# NorDig-Unified\_Test\_Plan\_ver\_2.6.0 – DVB-T/DVB-T2 PART

This document summarizes Silicon Labs understanding of current test plan and the needs of further clarification or update from NorDig when comparing latest test plan requirements with related NorDig unified requirements.

Figure 1 A flowchart for best service selection algorithm in case when two transmitters A and B transmit equal service and both of them are able to be received. ΔS and ΔQ refer to difference in SSI and SQI values and are defined as ΔS=10% and ΔQ=20%.

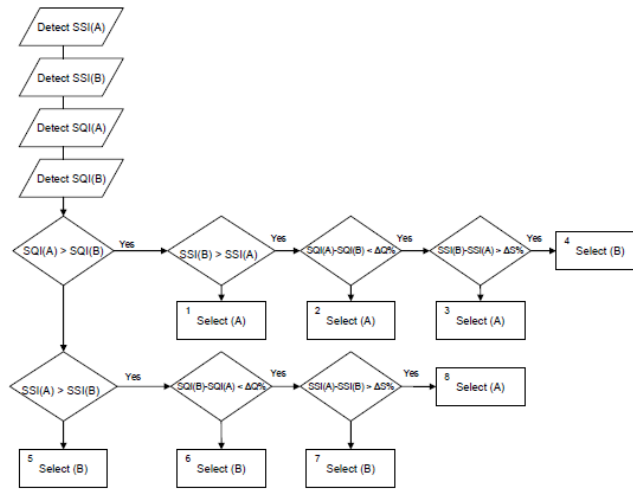
Per annex D of NorDig Unified requirements (ver2.6 or 3.0), flow chart numbers 3, 7, 2 and 6 requires delta SSI to be greater than 0, otherwise (delta SSI=0), 1 is tested instead of 2 or 3, 5 is tested instead of 6 or 7.

Considering that SSI slope of 4/dB for 64QAM 2/3 input power level <=-60dBm and SSI slope of 0.67/dB for input power level >=-60dBm, Silicon Labs recommends to update NorDig default levels from -60dBm to -58dBm to reduce probability that delta SSI=0 while keeping delta SSI<=10 as shown in SiLabs tuner/demodulator test reports.

To validate flowchart numbers 3, 7, 2 and 6, delta SSI shall be greater than 0. This requires modifications of NorDig default levels applied.

Figure 1 A flowchart for best service selection algorithm in case when two transmitters A and B transmit equal service and both of them are able to be received. ΔS and ΔQ refer to difference in SSI and SQI values and are defined as ΔS=10% and ΔQ=20%.

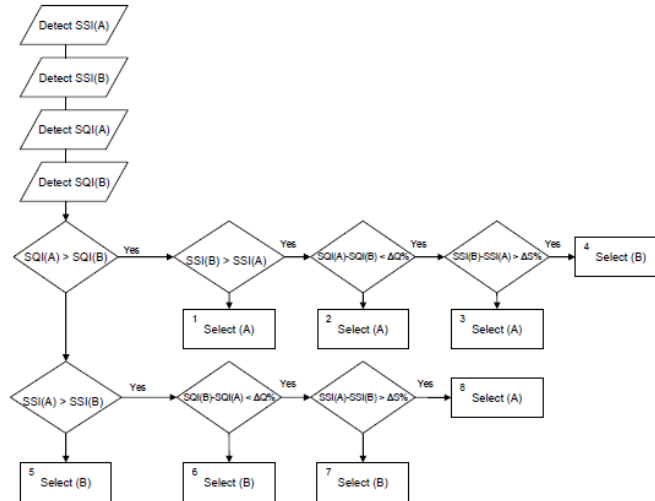
Per annex D of NorDig Unified requirements (ver2.6 or 3.0), flow chart numbers 3, 7, 2 and 6 requires delta SSI to be greater than 0, otherwise (delta SSI=0), 1 is tested instead of 2 or 3, 5 is tested instead of 6 or 7.

Considering that SSI slope of 4/dB for 64QAM 2/3 input power level <= -60dBm and SSI slope of 0.67/dB for input power level >= -60dBm, Silicon Labs recommends to update NorDig default levels to at least -58dBm (instead of -60dBm) to reduce probability that delta SSI=0 while keeping delta SSI<=10 as shown in SiLabs tuner/demodulator test reports.
